## UHF ASK/FSK Receiver

**ATA5721**  
**ATA5722**

## **2. Change Notice Based on Datasheet ATA5823/ATA5824 -- UHF ASK/FSK Transceiver Rev. 4829D-RKE-06/06**

Figure 1-1. Pinning QFN48

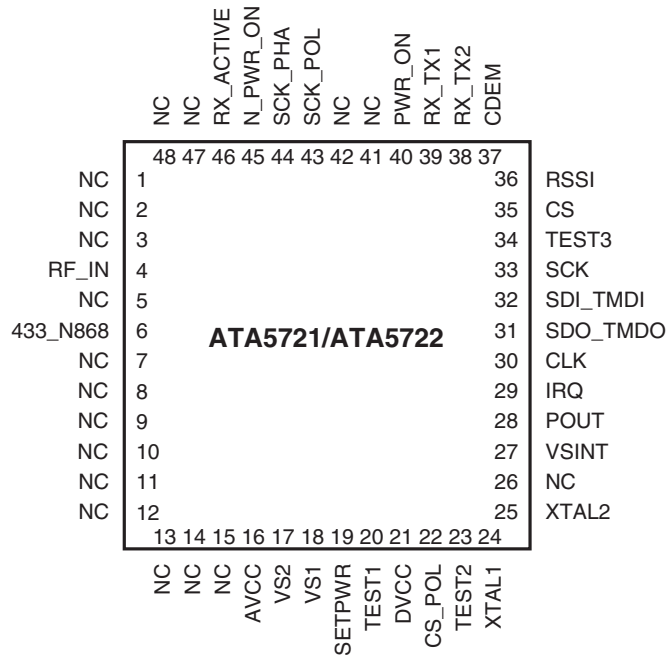
Unlike the transceiver, the receiver does not have the transmit functionality, and pins 8, 9 and 10 are not connected. The only change to the receiver is that it has a different bonding inside to disable the TX functionality.

- IC changed from transceiver to receiver due to removed TX functionality
- Device type numbers changed from ATA5823 to ATA5721 (313-MHz to 316-MHz version) and from ATA5824 into ATA5722 (433-MHz to 435-MHz version)
- No TX operation mode available due to removed bondwires of pins 8, 9 and 10
- Pins 8, 9 and 10 are NC (not connected) and have to be soldered to GND on the PCB
- No full-duplex operation mode possible
- All descriptions of TX operation in half-duplex mode are not valid
- The receiver type ATA5722 is only specified and tested in the frequency range of 433 MHz to 435 MHz, receive functionality in the 867-MHz to 870-MHz frequency band is neither specified nor tested.
- All descriptions of 867-MHz to 870-MHz applications are not valid.
